IREDELL COUNTY HEALTH DEPARTMENT

Statesville Office (704) 878-5305 Mooresville Office (704) 660-3625 PERMIT # 225200

IMPROVEMENT PERMIT / AUTHORIZATION TO CONSTRUCT / OPERATION PERMIT / EXISTING SYSTEM

APPLICANT: Lonnie Wilson APPLICANT ADDRESS: 105 Abbeville. Mooresville, NC

AS BUILT SKETCH

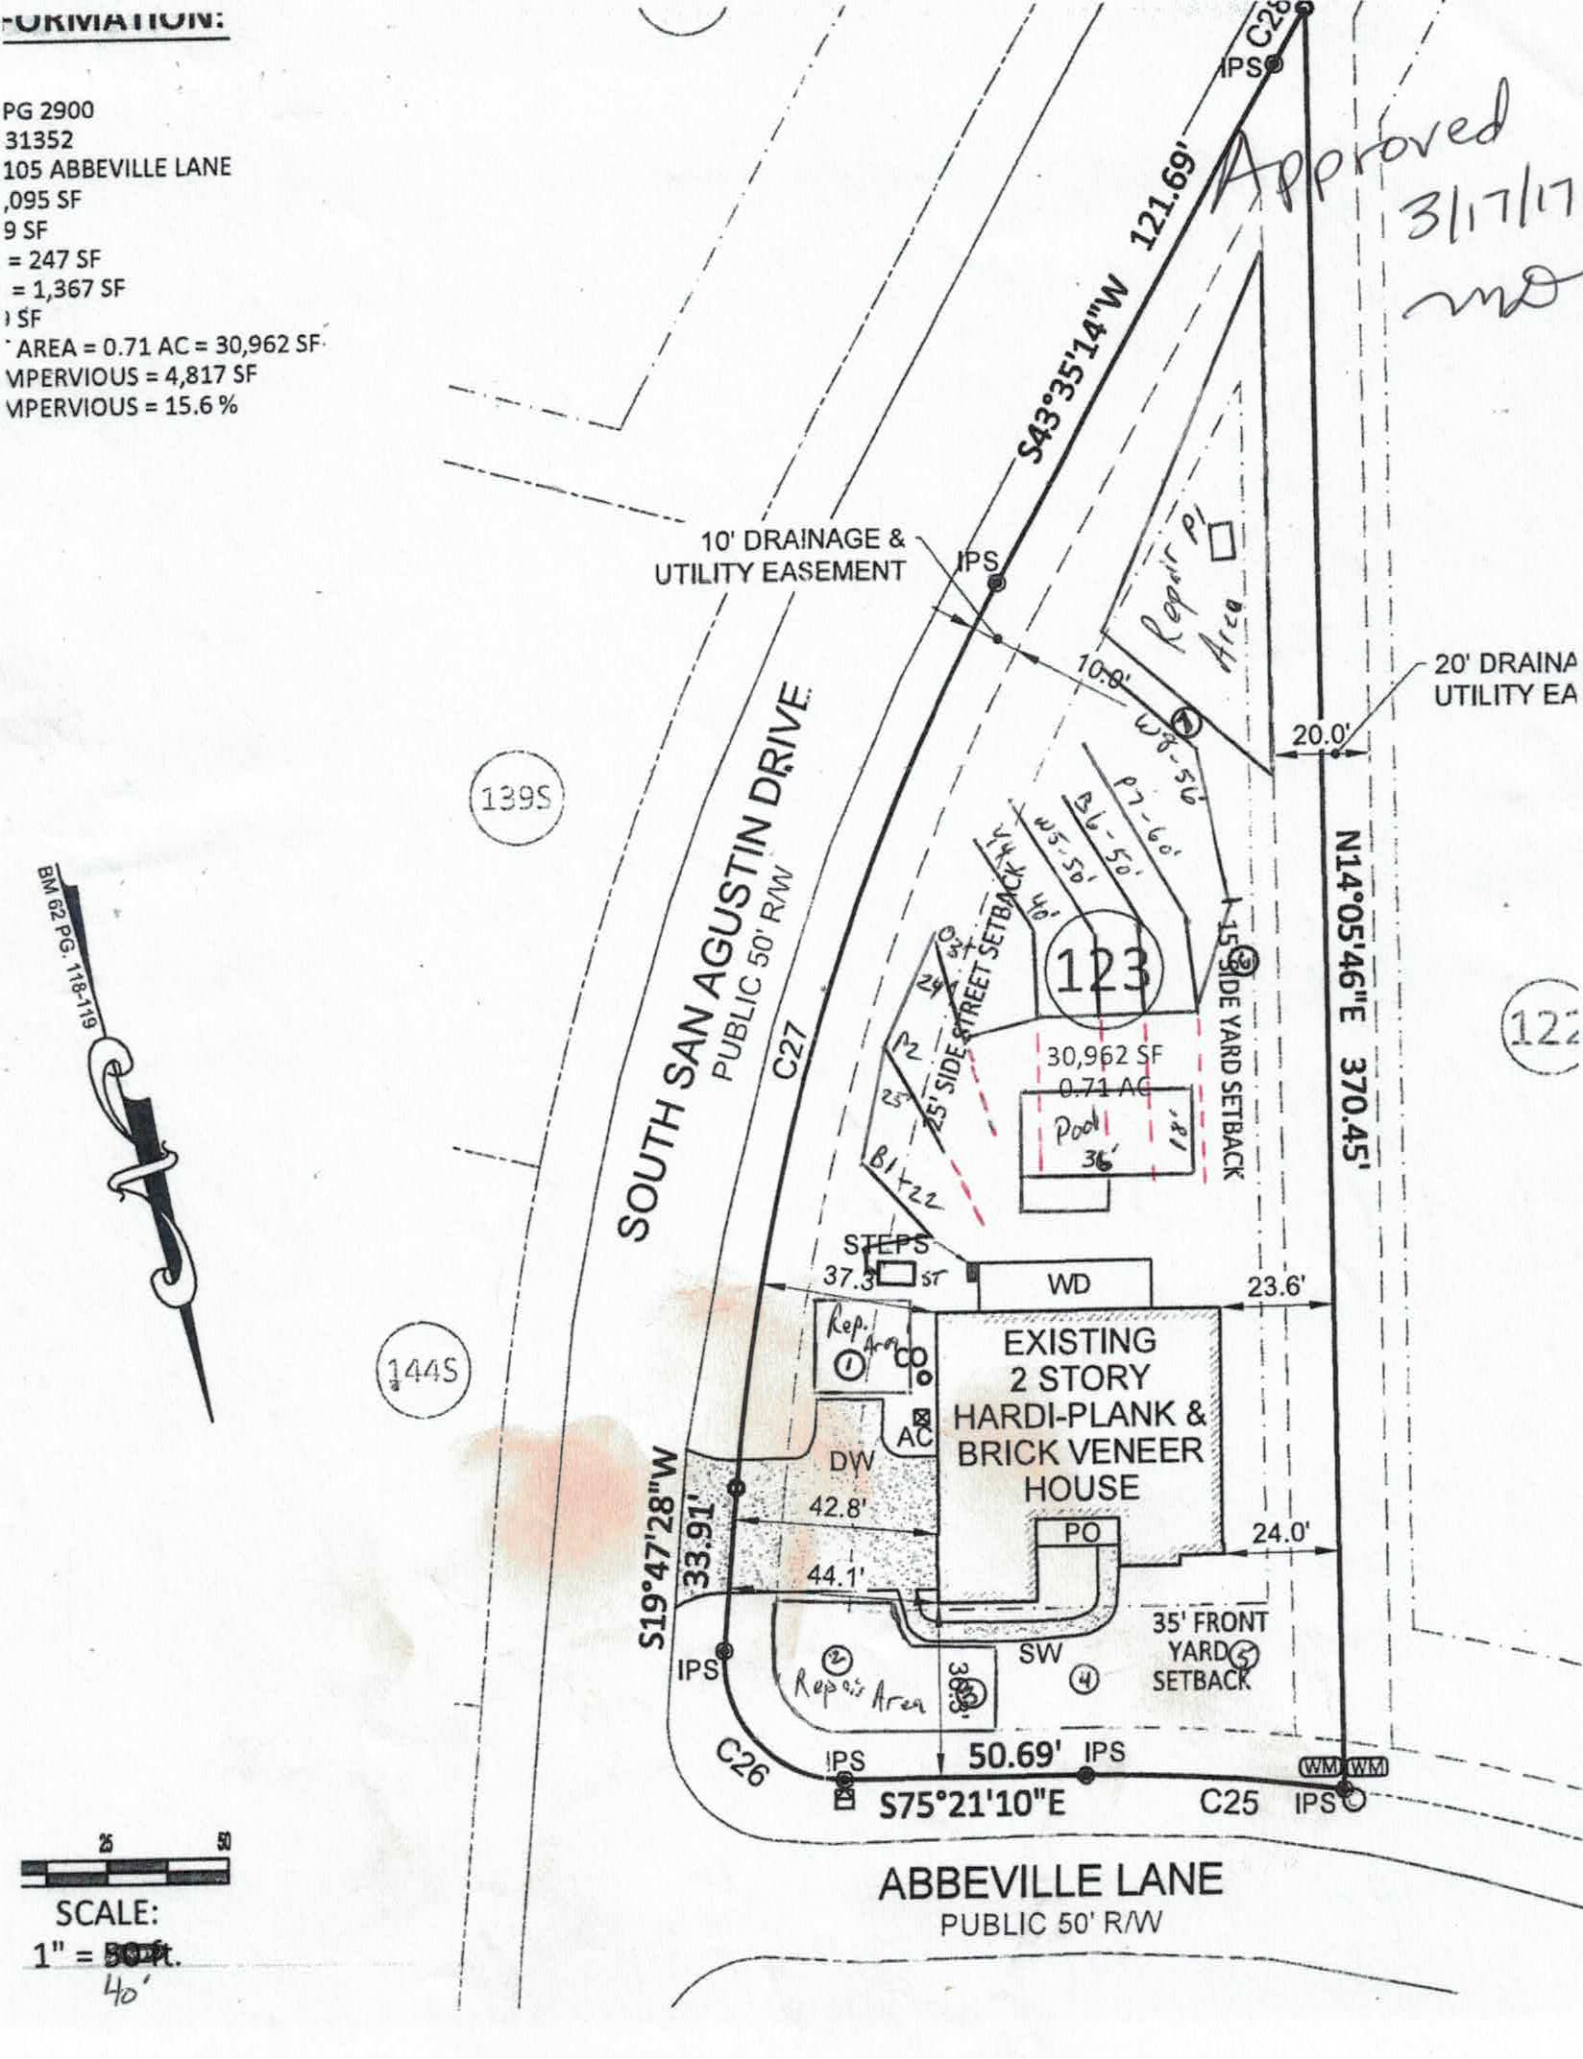
Comments / Conditions: Note: Follow plan carefully, some drainlines will be shortened to meet 15ft setback to pool.
** Changes to Septic System must be Completed prior to excavating for pool.

* Owners are reducing bedrooms from 4 to 3 bedrooms to accomodate swimming pool.

Installed new drainline & cut off others @ 15ft from pool.
